File No. 7400-54-DTTP

Re: VPA Comments on the Vancouver Downtown Transportation Plan Draft Report

Figure 1: Excerpt from Central Waterfront Port Lands Policy Statement

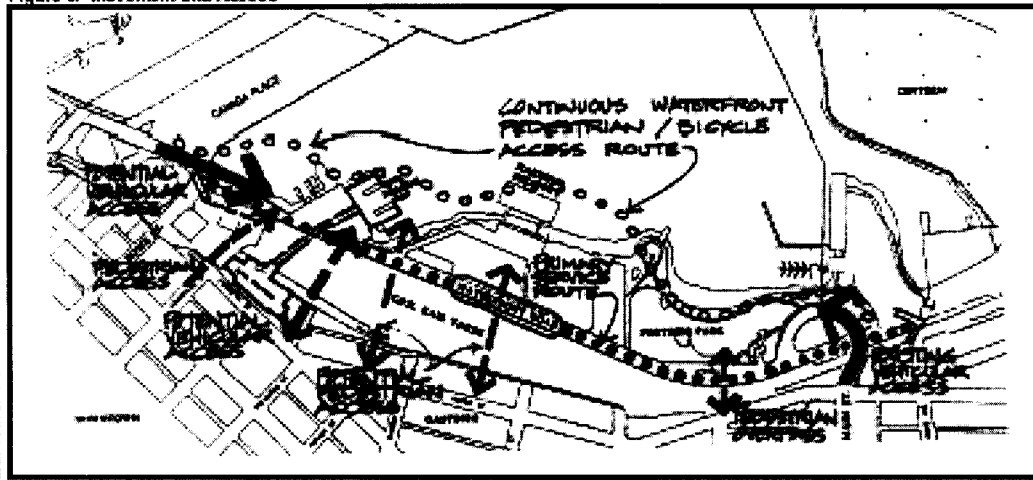
While VPA is fully supportive of pedestrian routes and greenways in and around the downtown area the report may benefit from some modifications to the graphics and text as they relate to the area around Canada Place and the Lower Port Road. The graphics imply specific alignments that simply may not be possible. Perhaps a more generic approach would be better given that no development plans for the area have yet been completed. Please refer to the Central Waterfront Port Lands Policy Statement as it relates to movement and access (see Figure 1 below). In addition, VPA takes the position of not encouraging the lower level road – beneath Canada Place - for use by pedestrians especially in the short term. Pedestrian activity in this area is not compatible with the bus, truck and other vehicular activities taking place in this area. The “tunnel” area will only expand in the future and will likely become an even less friendly environment for pedestrians. This would be similar to encouraging pedestrians to use back lanes in other parts of downtown where loading/deliveries are made versus the use of the upper level sidewalk.

Figure 1: Excerpt from Central Waterfront Port Lands Policy Statement

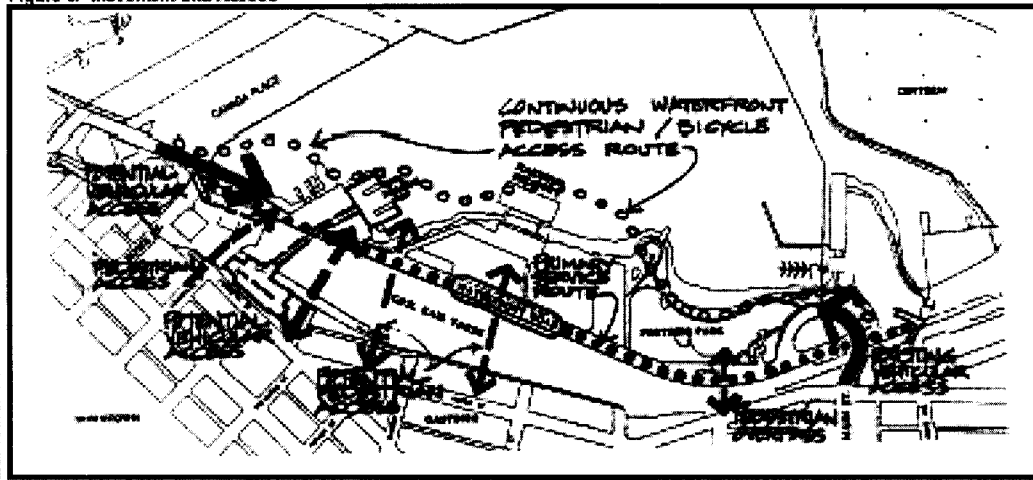
While VPA is fully supportive of pedestrian routes and greenways in and around the downtown area the report may benefit from some modifications to the graphics and text as they relate to the area around Canada Place and the Lower Port Road. The graphics imply specific alignments that simply may not be possible. Perhaps a more generic approach would be better given that no development plans for the area have yet been completed. Please refer to the Central Waterfront Port Lands Policy Statement as it relates to movement and access (see Figure 1 below). In addition, VPA takes the position of not encouraging the lower level road – beneath Canada Place - for use by pedestrians especially in the short term. Pedestrian activity in this area is not compatible with the bus, truck and other vehicular activities taking place in this area. The “tunnel” area will only expand in the future and will likely become an even less friendly environment for pedestrians. This would be similar to encouraging pedestrians to use back lanes in other parts of downtown where loading/deliveries are made versus the use of the upper level sidewalk.
